PROPOSAL REQUEST

JLG 18126 Eastgate Apartments

Issued: December 22, 2020

PROPOSAL REQUEST #: 03

1A
A200 GROUND FLOOR PLAN
 SCALE: 1/8" = 1'-0"

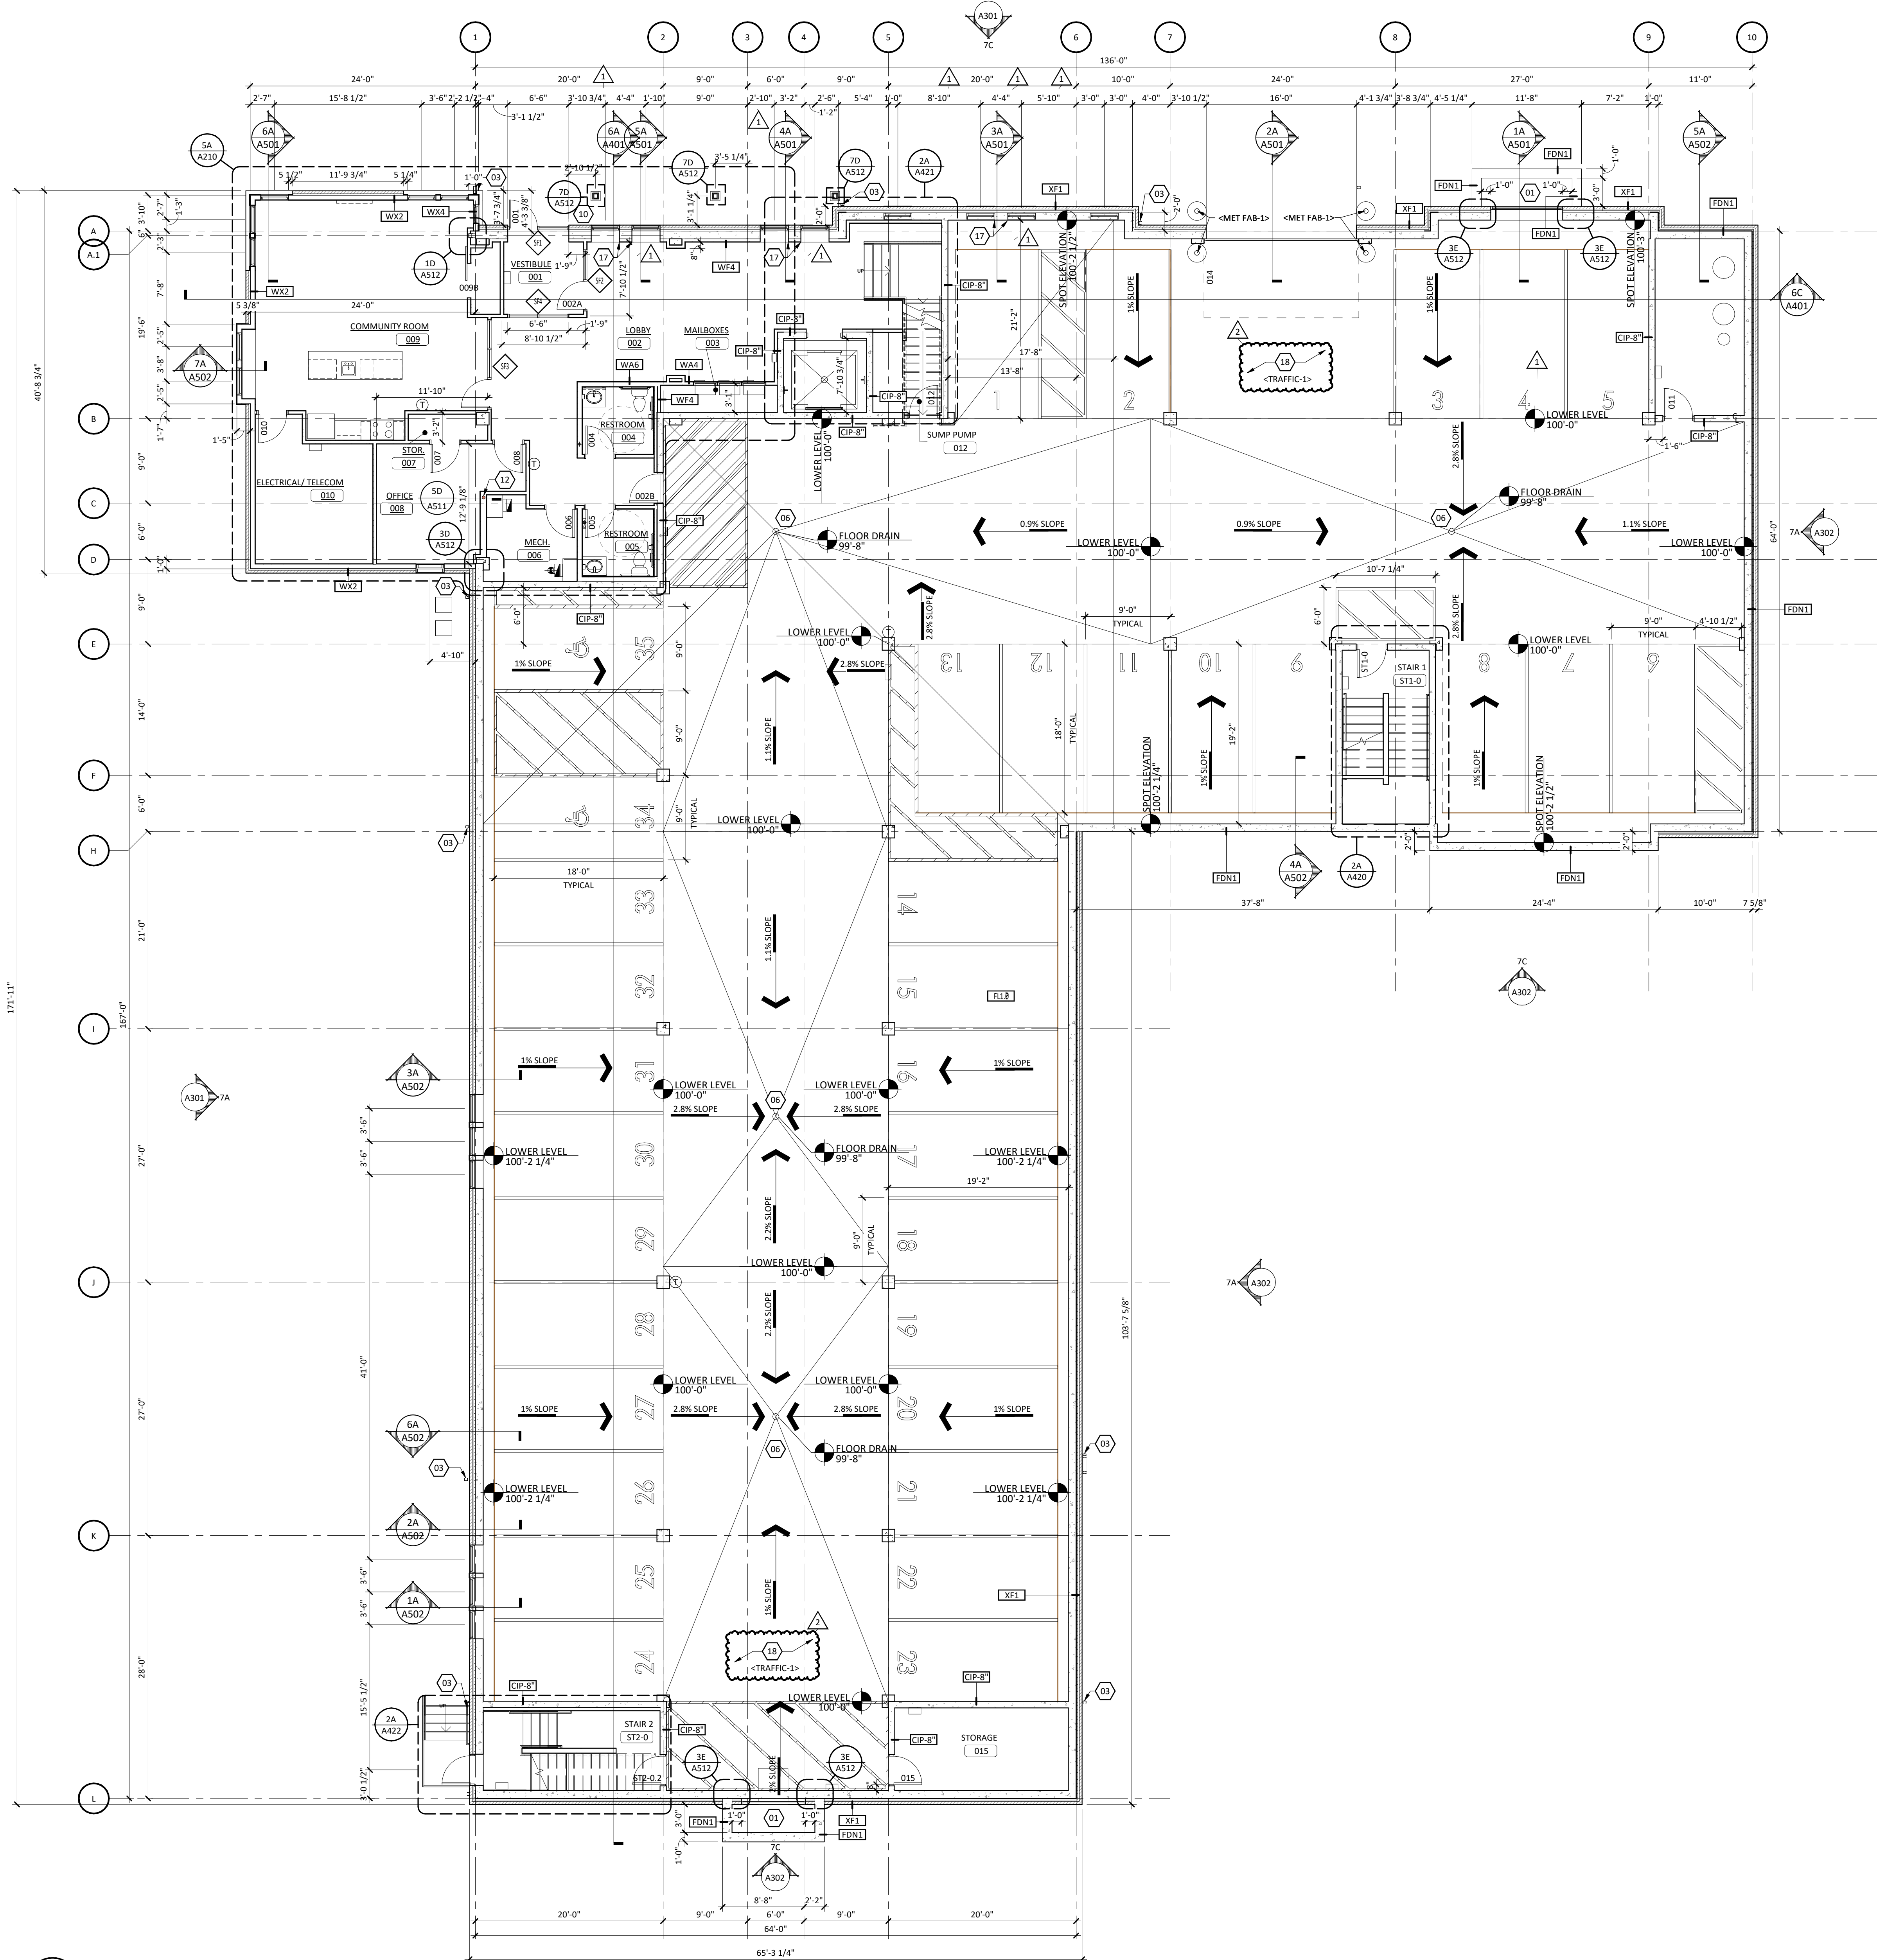
1. A200 - GROUND FLOOR PLAN
 - o Added notes to Keynotes and located on Floor Plan
 - o Added General Notes
2. A204 - ROOF PLAN
 - o Added Roof Plan Keynote and located on Roof Plan
3. A421 - VERTICAL CIRCULATION
 - o Modified wall location in Sump Pump #012 on 2A/A421.

1 GROUND FLOOR - HVAC PLAN
0 4' 8' 16'

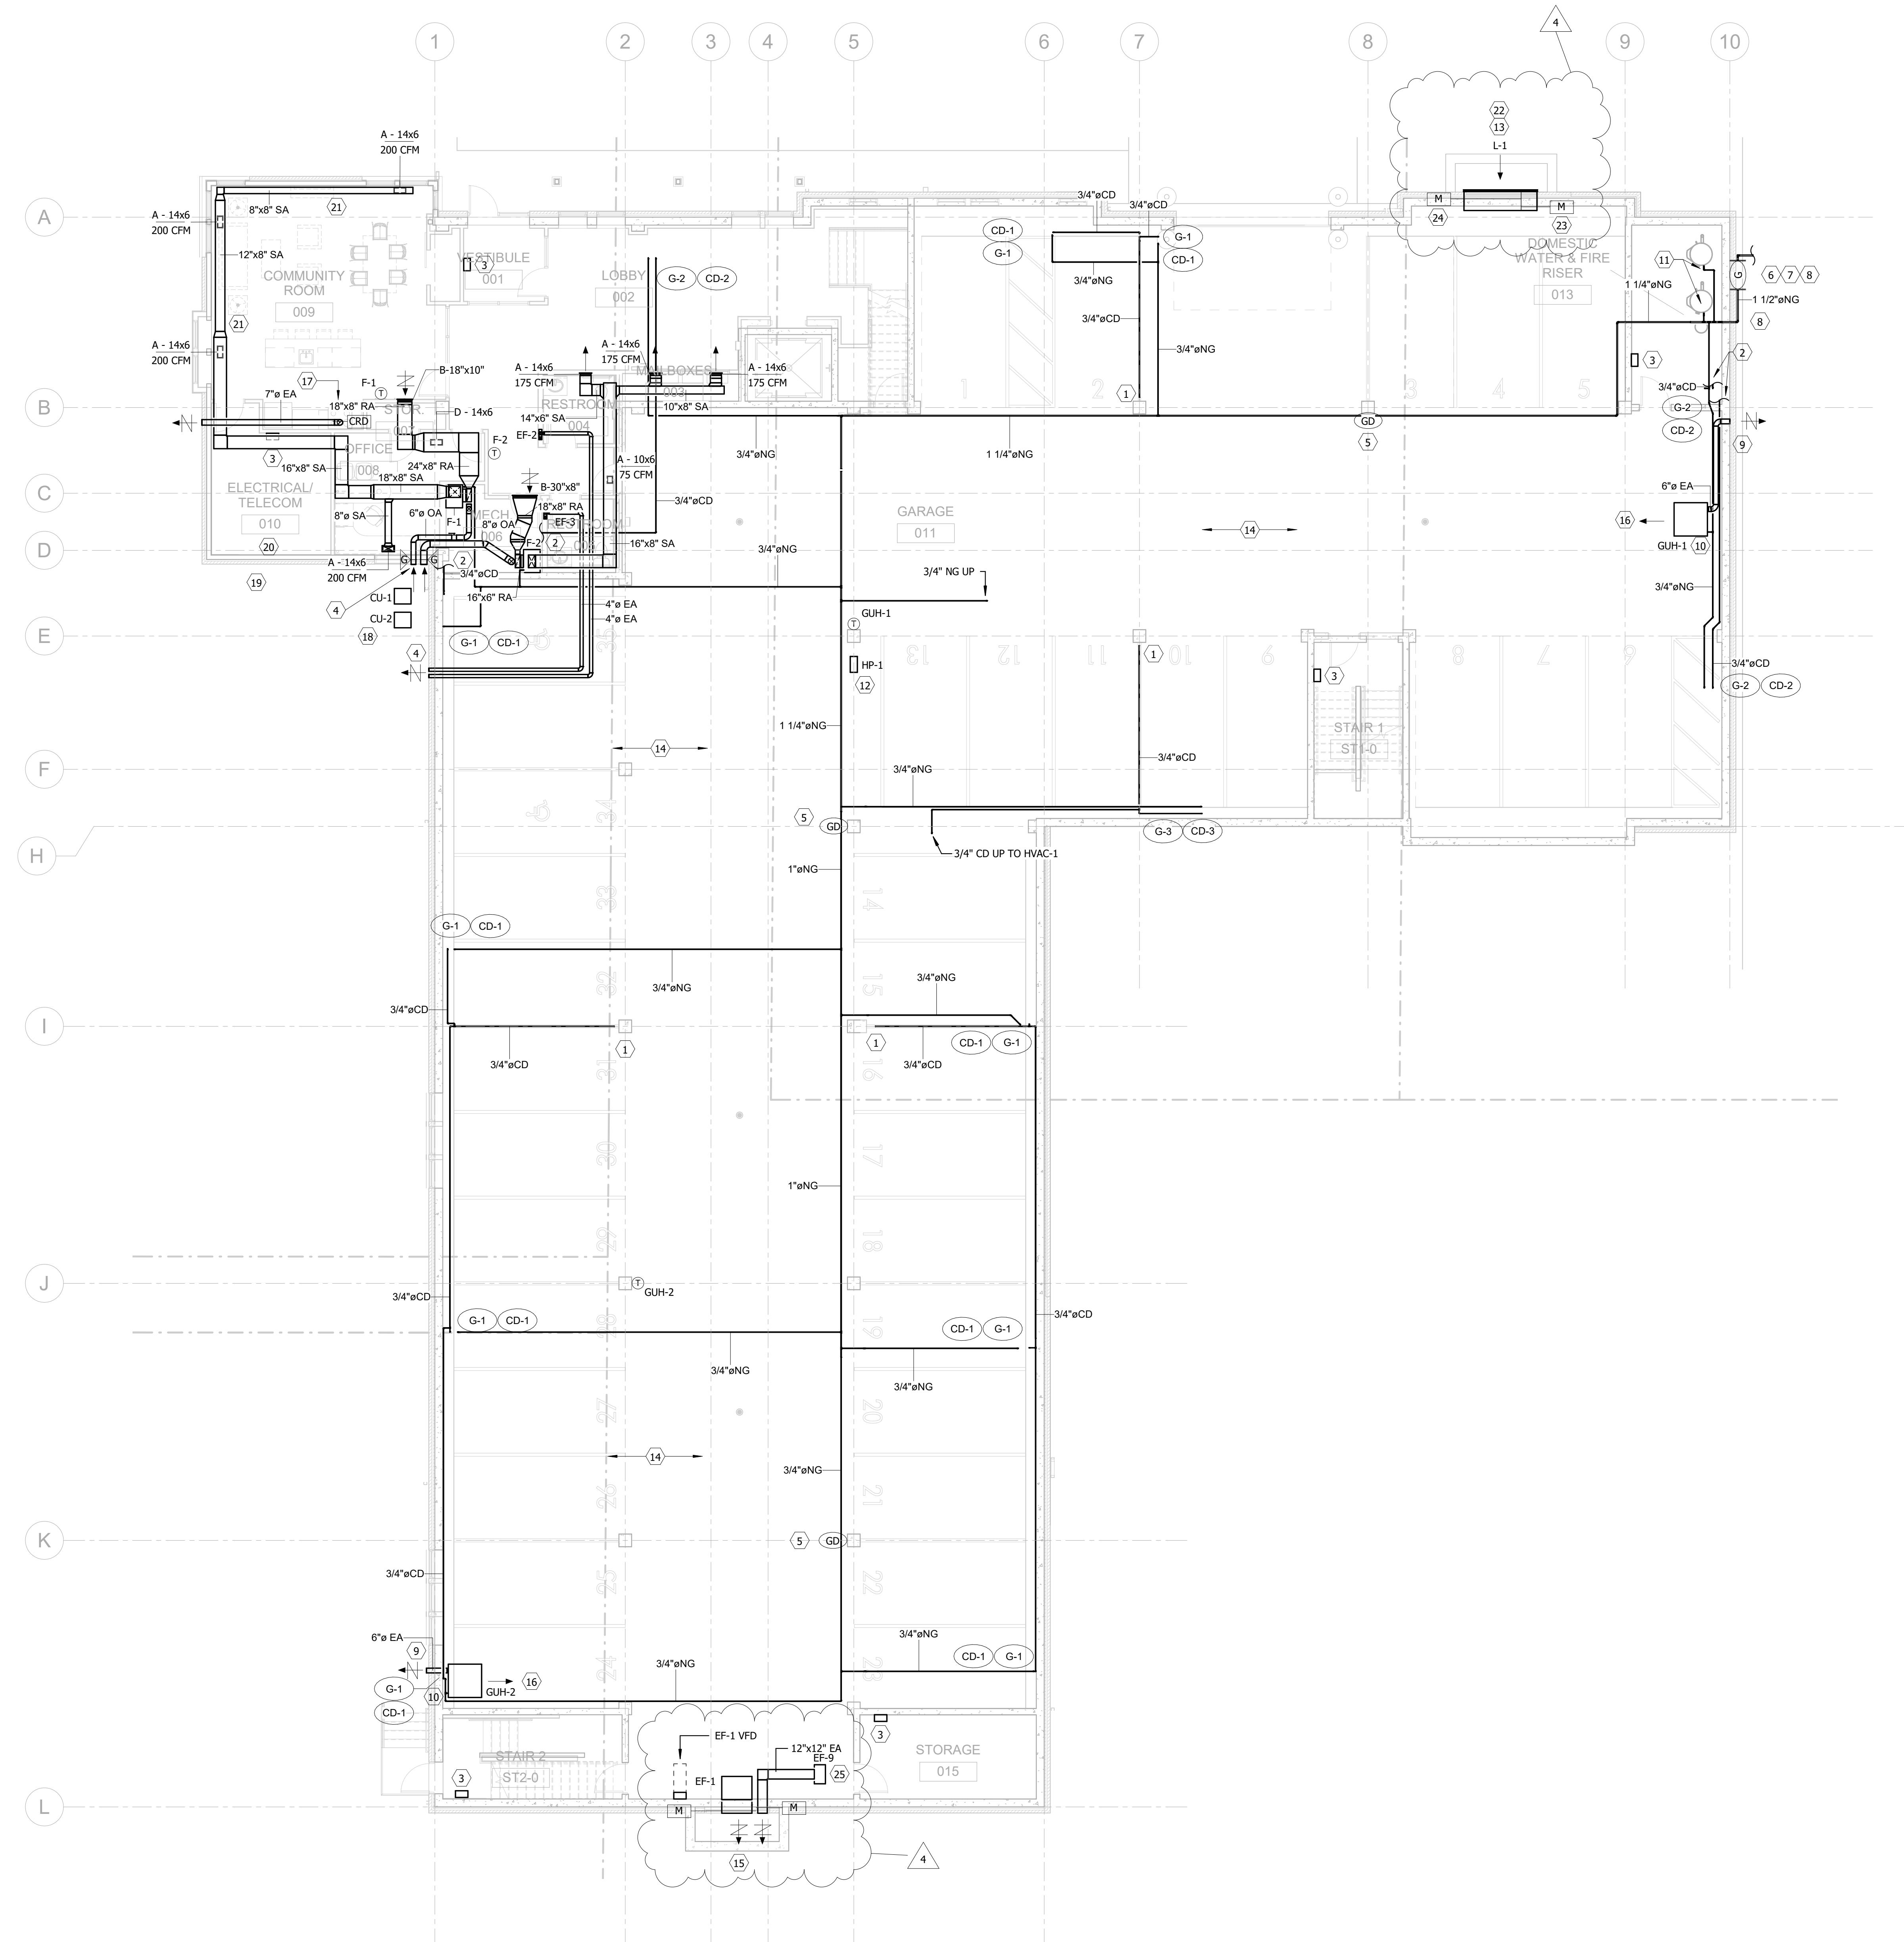
- Item No 01: Drawing M001 – Mechanical Symbols and Legend
 - a) Added general note FF.
- Item No 02: Drawing M300 – Ground Floor HVAC Plan
 - a) Added EF-9 and associated ductwork.

- b) Revised L-1.
 - c) Added keynotes 22, 23, 24, and 25.
- Item No 03: Drawing M301 – First Floor HVAC Plan
 - a) Added supply air to stairwells.
 - b) Revised F-3 air distribution.

- COORDINATE DUCT ROUTING WITH ARCHITECTURAL SOFFIT.
- SPLIT LOUVER INTO 2 SECTIONS, ONE 20" W X 50" H AND ONE 72" W X 50" H, EACH WITH INDEPENDENT MOTORIZED DAMPERS.

- INTERLOCK DAMPER WITH VAPOR MITIGATION FAN (CONTINUOUS OPERATION).
- INTERLOCK DAMPER WITH EF-1.
- EF-9 SHALL RUN CONTINUOUSLY TO PROVIDE MINIMUM 0.05 CFM PER SF VENTILATION PER MPCA VAPOR MITIGATION BEST PRACTICES.

1 FIRST FLOOR - HVAC PLAN
0 4' 8' 16'

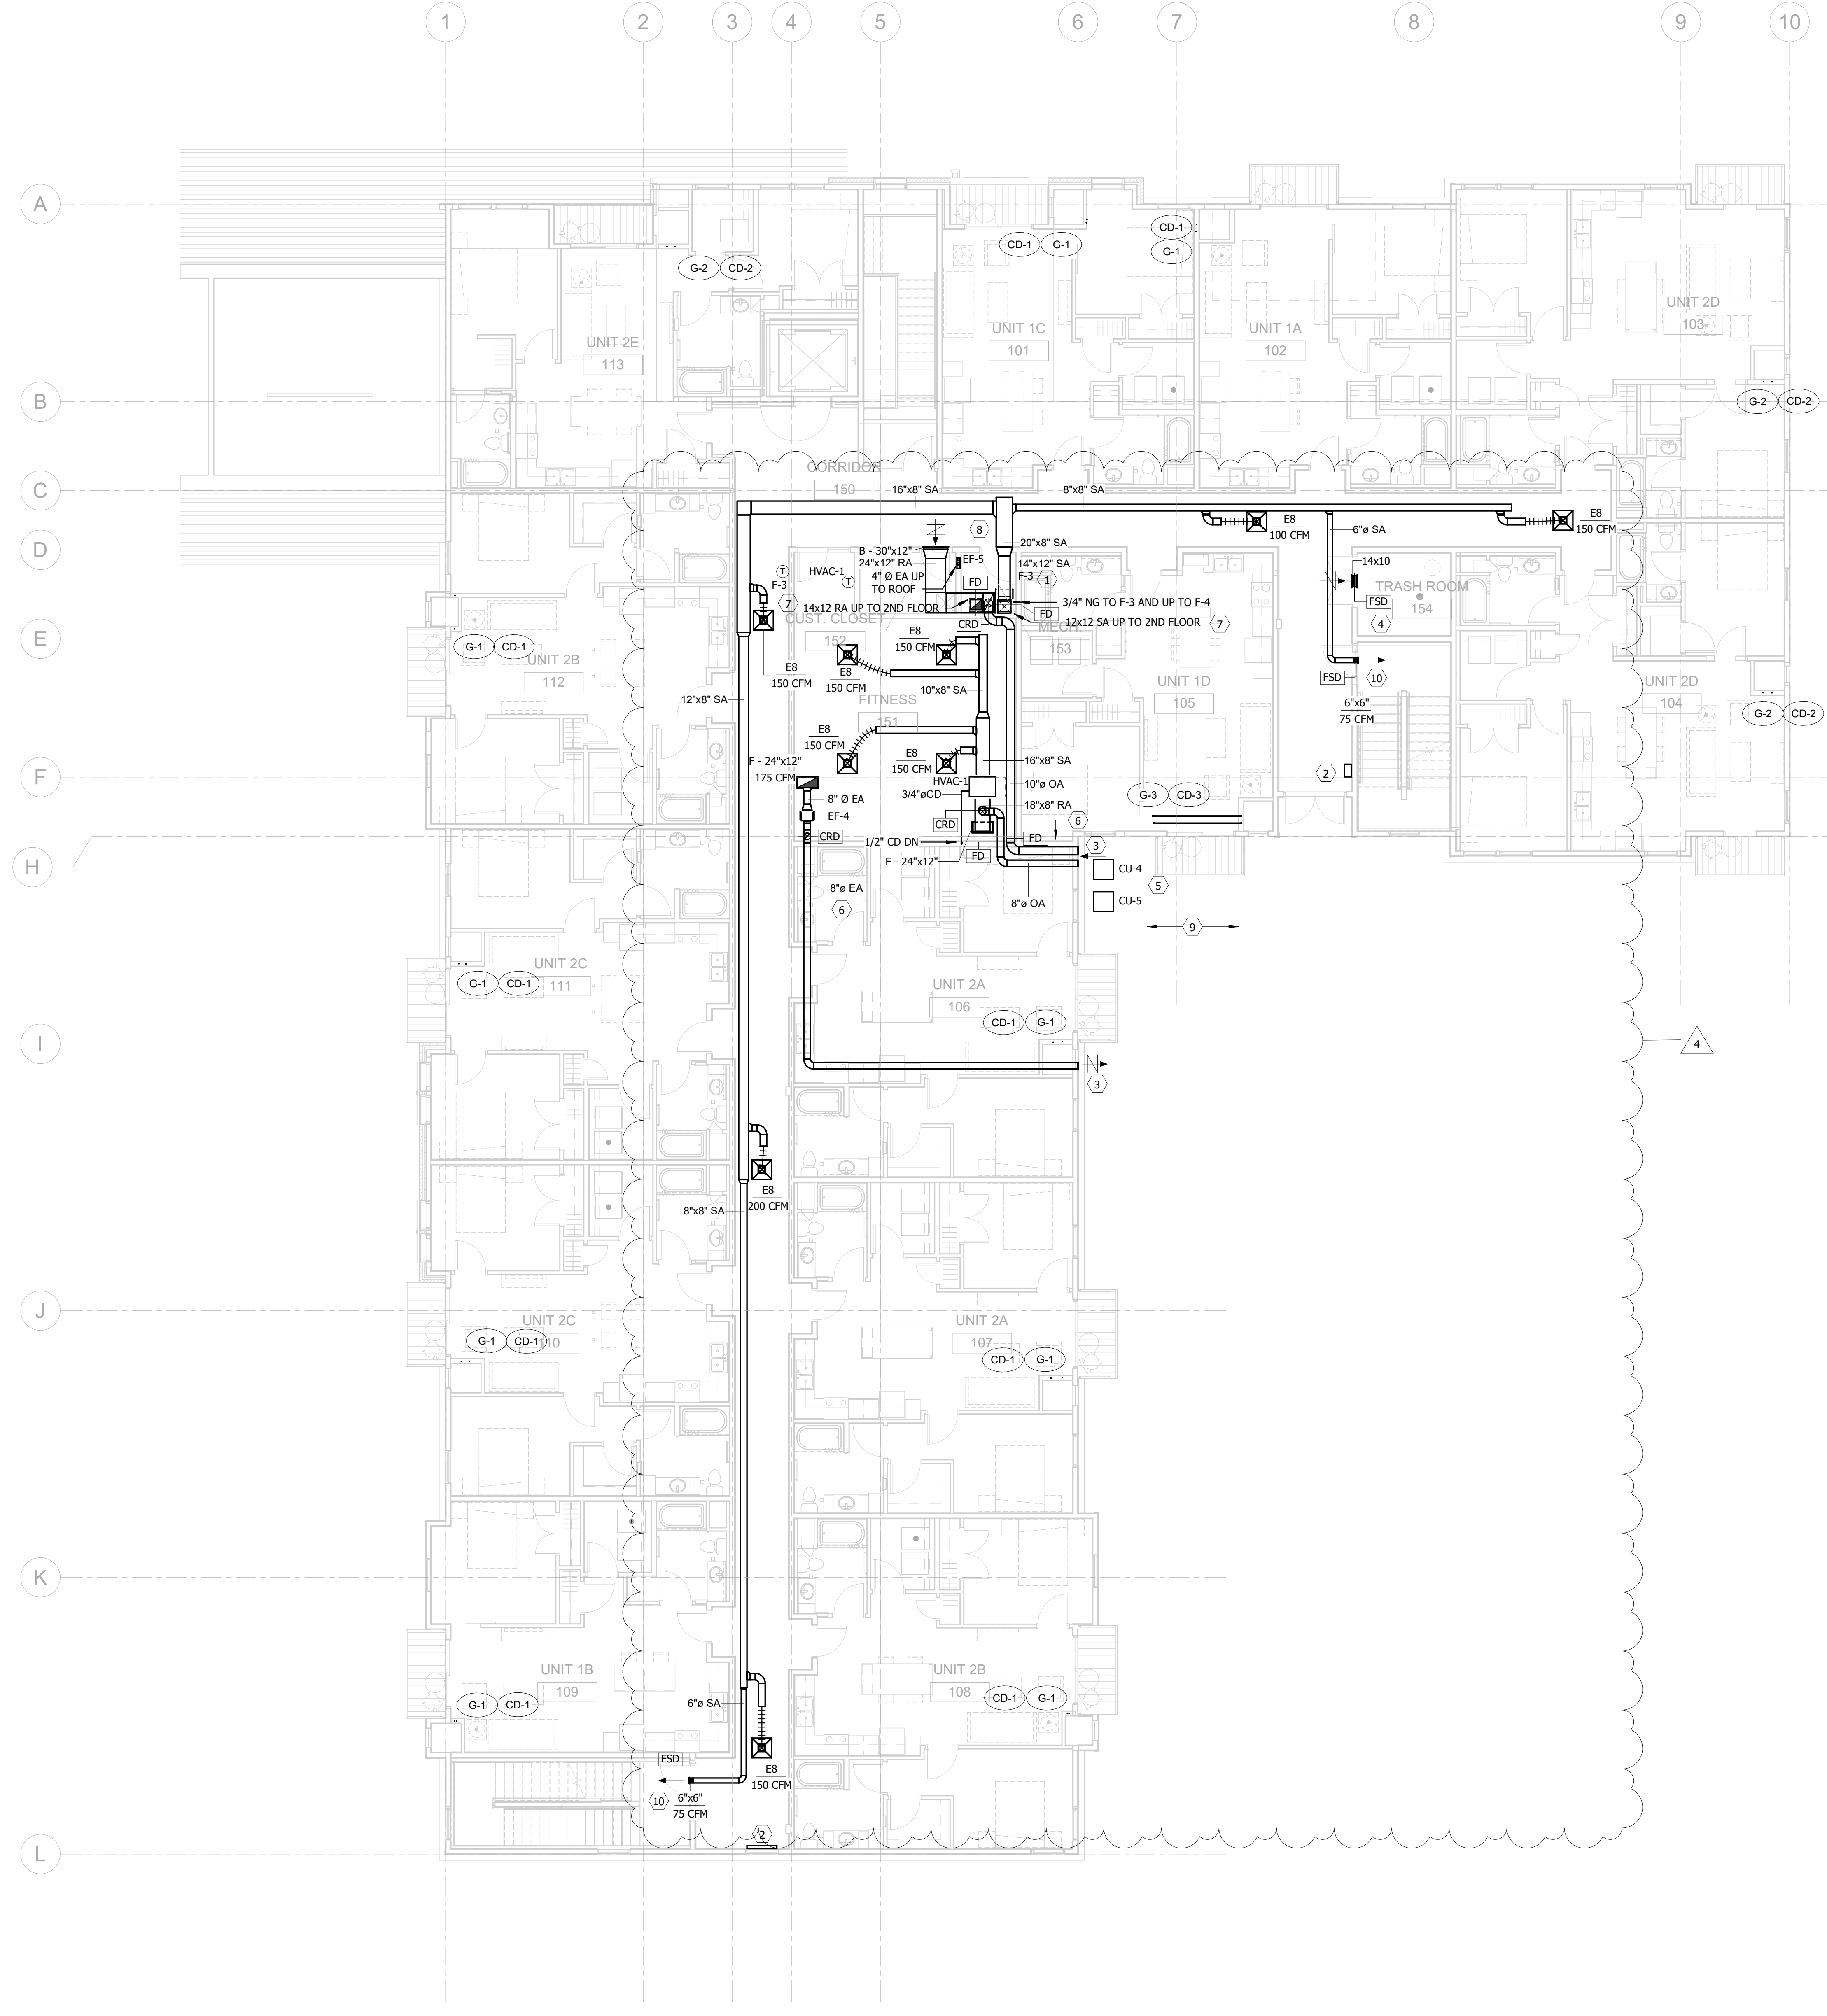
- c) Added keynote 10.
- Item No 04: Drawing M303 – Third Floor HVAC Plan
 - a) Added supply air to elevator hoistway.
 - b) Revised F-4 air distribution.

- SUPPLY AIR TO STAIRWELL SHALL PROVIDE POSITIVE PRESSURIZATION PER MPCA VAPOR MITIGATION BEST PRACTICES.
